**SUBJECT: CHANGE ORDER – WATER POLLUTION CONTROL FACILITY  
STRUCTURAL REHABILITATION PROJECT PHASE 2**

<b>CHANGE ORDER NO. 2</b>	
<b>CONTRACT / BID NO:</b>	<b>2018-163</b>
<b>PURCHASE ORDER NO:</b>	<b>55717</b>

<b>Project:</b>	<b>Ames Water Pollution Control Facility Structural Rehabilitation Phase 2</b>
-----------------	--

RE: WPCF STRUCTURAL REHABILITATION PHASE 2  
AMES, IOWA  
PROPOSAL.05RR

REVISIONS TO DETAIL A 103A101

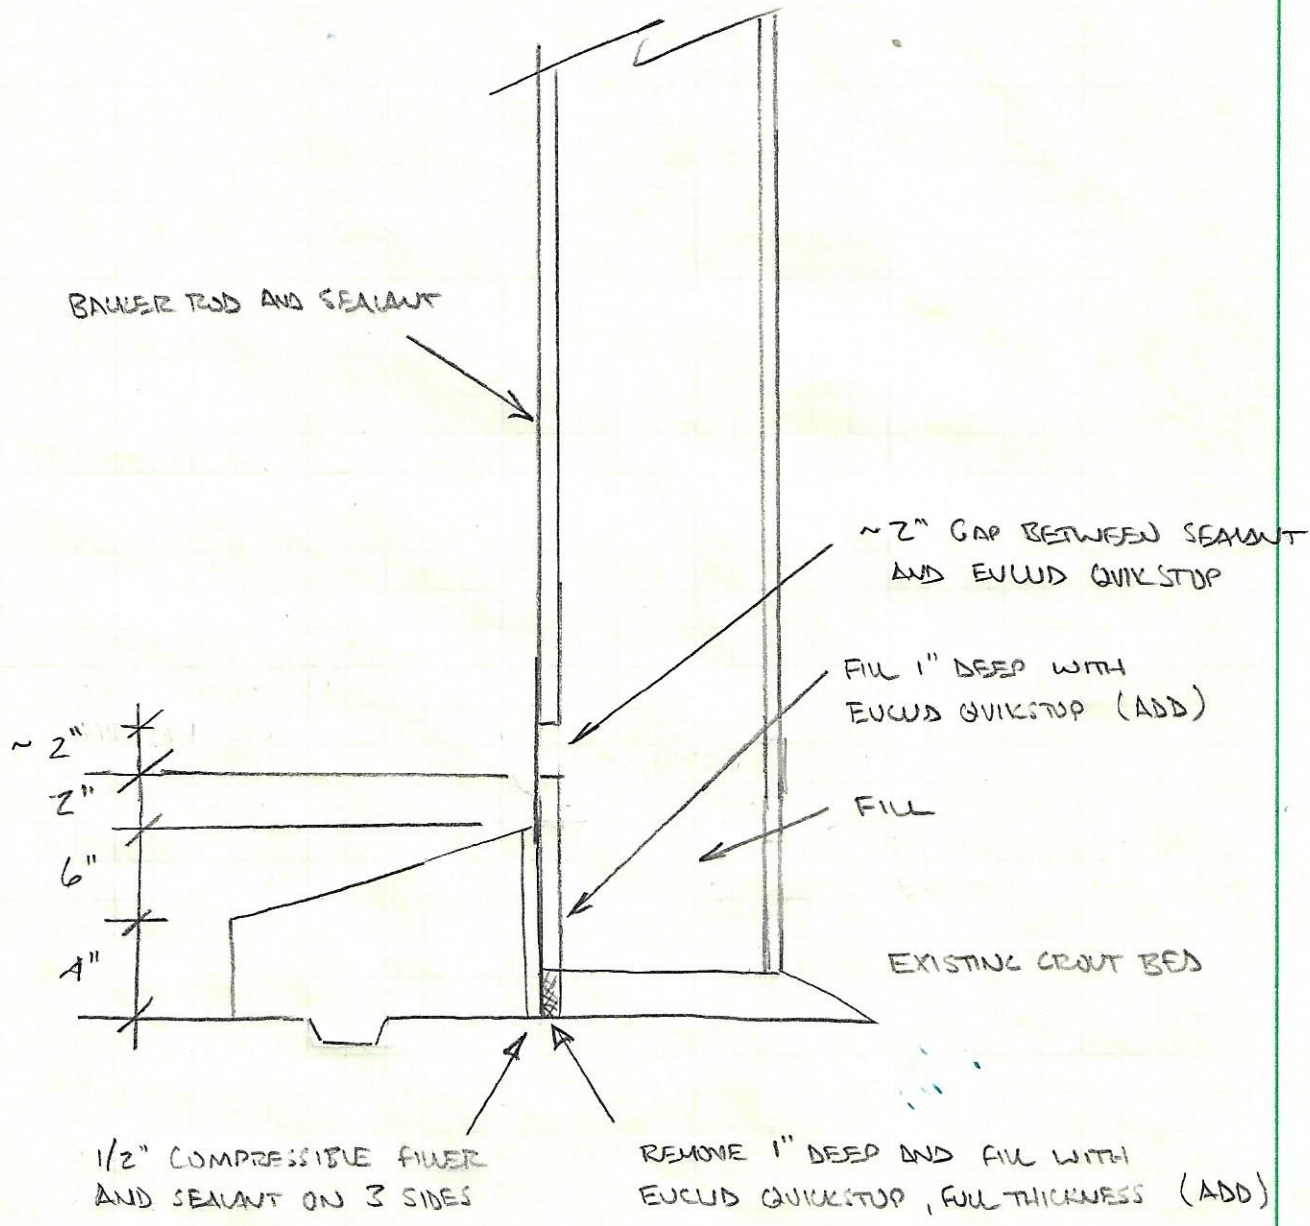
DESCRIPTION OF WORK: INSTALL WATERSTOP IN HORIZONTAL AND VERTICAL JOINTS BEHIND FILLETS

REVISIONS TO DETAIL S / 00AS01 (TRICKLING FILTERS ONLY)

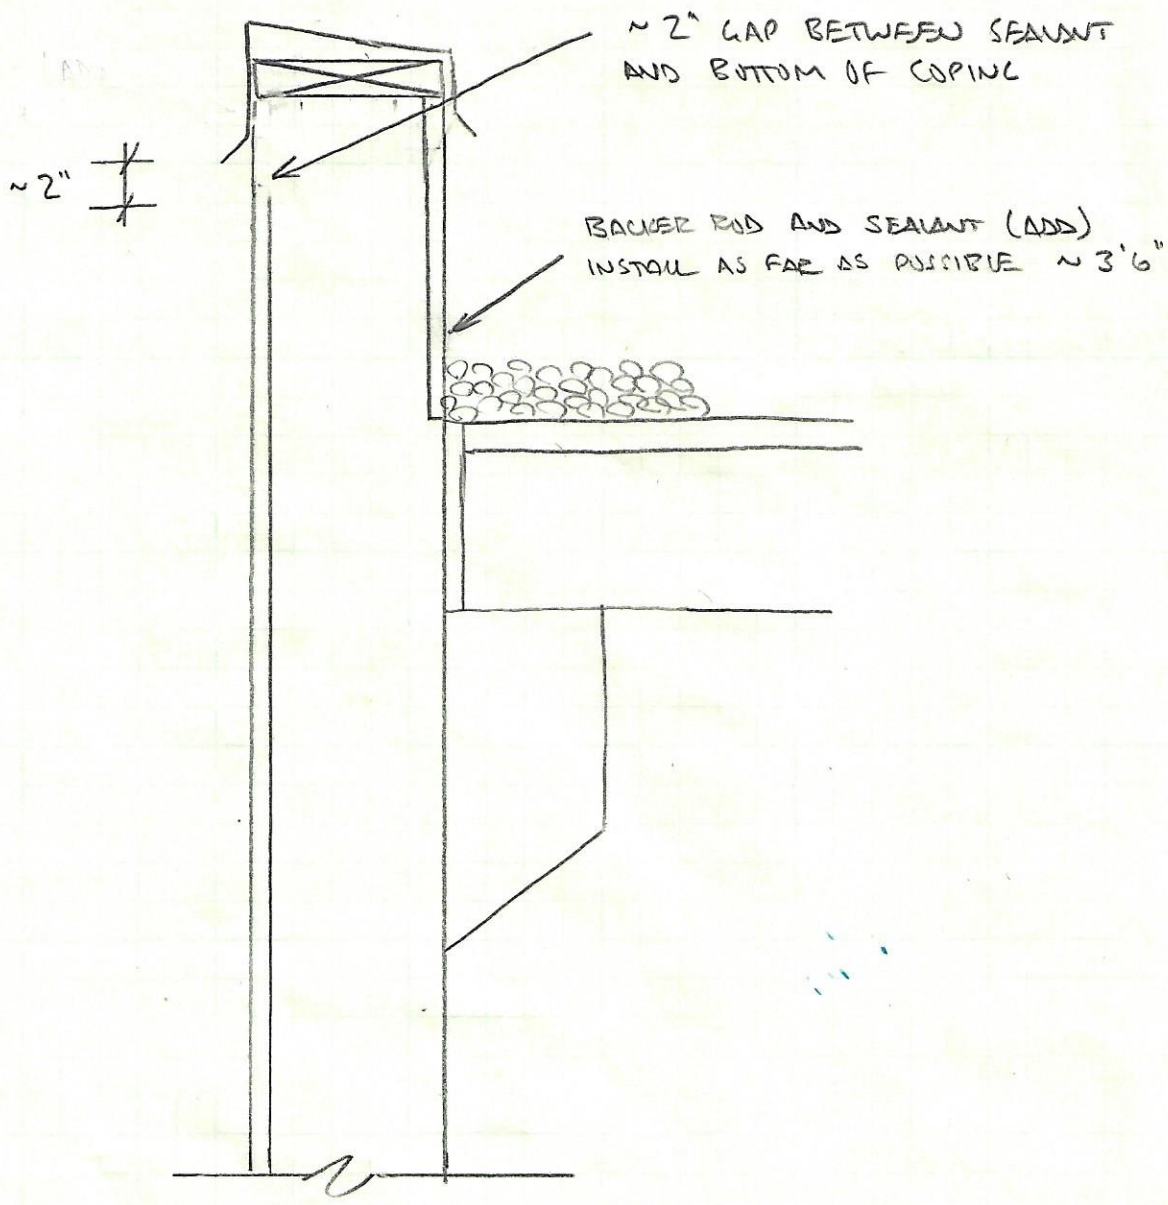
DESCRIPTION OF WORK: REMOVE AND REPLACE SEALANT ON INTERIOR OF TRICKLING FILTER PARAPET WALLS
